**Resource Consent Application RM23–0010 for comprehensive stormwater consent for existing stormwater discharges from the Whakatane Township and associated network structures located in the bed/bank of a river or stream, and/or the CMA – Clarifications to Request for Further Information pursuant to Section 92 of the Resource Management Act 1991 (RMA)**

**RE: RESOURCE CONSENT APPLICATION RM23-0010 FOR COMPREHENSIVE STORMWATER CONSENT FOR EXISTING STORMWATER DISCHARGES FROM THE WHAKATANE TOWNSHIP AND ASSOCIATED NETWORK STRUCTURES LOCATED IN THE BED/BANK OF A RIVER OR STREAM, AND/OR THE CMA – REQUEST FOR FURTHER INFORMATION PURSUANT TO SECTION 92 OF THE RESOURCE MANAGEMENT ACT 1991 (RMA)**

Client	WHAKATANE DISTRICT COUNCIL
Project	AWATAPU LAGOON FLOOD PUMPSTATION
Title	PUMP STATION TO OUTFALL LONGITUDINAL SECTION
Sheet No	A1
Drawing No	51-24371-C044
Rev	0

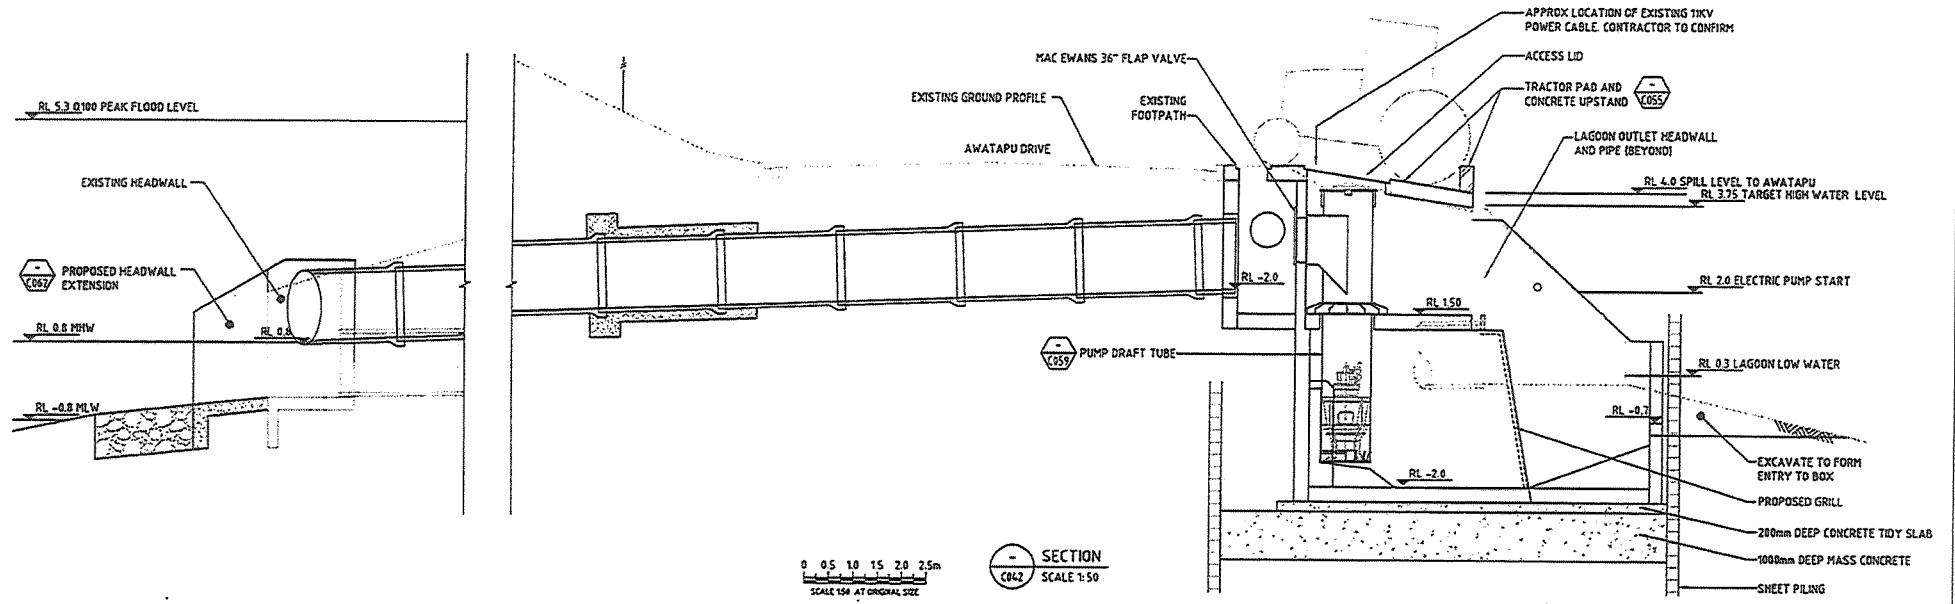
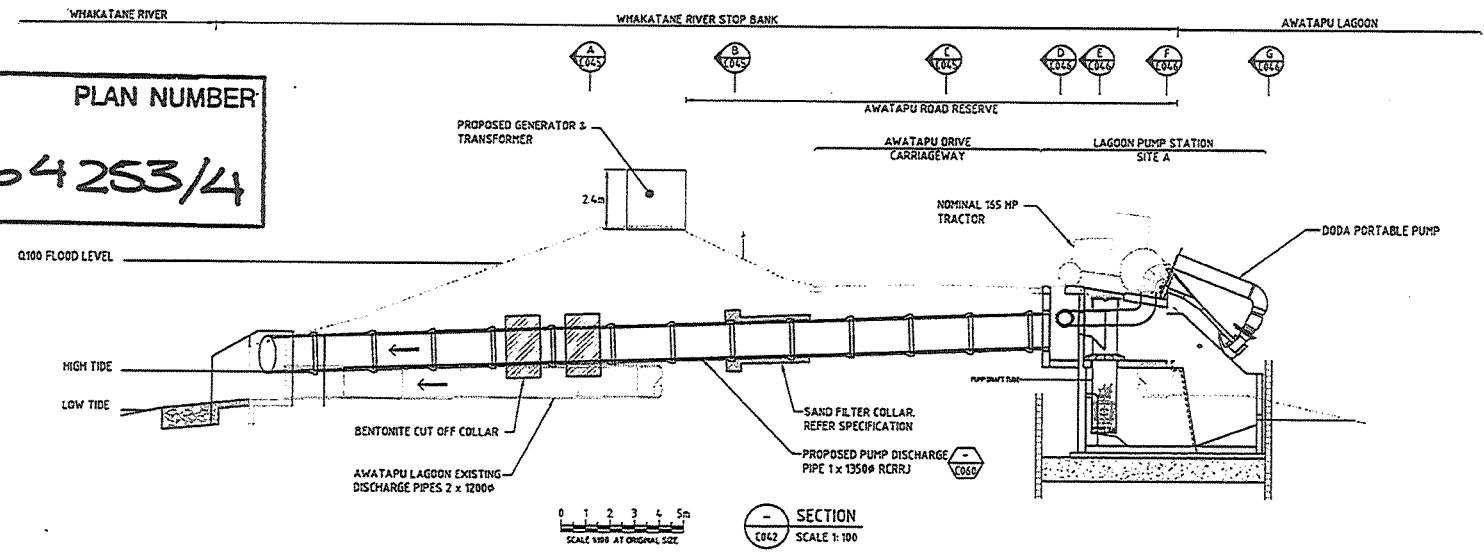
6.4 The consent holder shall ensure two intake screens are installed in accordance with GHD Drawing No: 51-24371-C044 Revision 0 entitled "Pumpstation to Outfall Longitudinal Section" and referenced as BOPRC Plan RC 64253/4.

6) The intake will have a screen. This screen is shown in drawing 51-24371-C attached. This will prevent entry from the intake side.
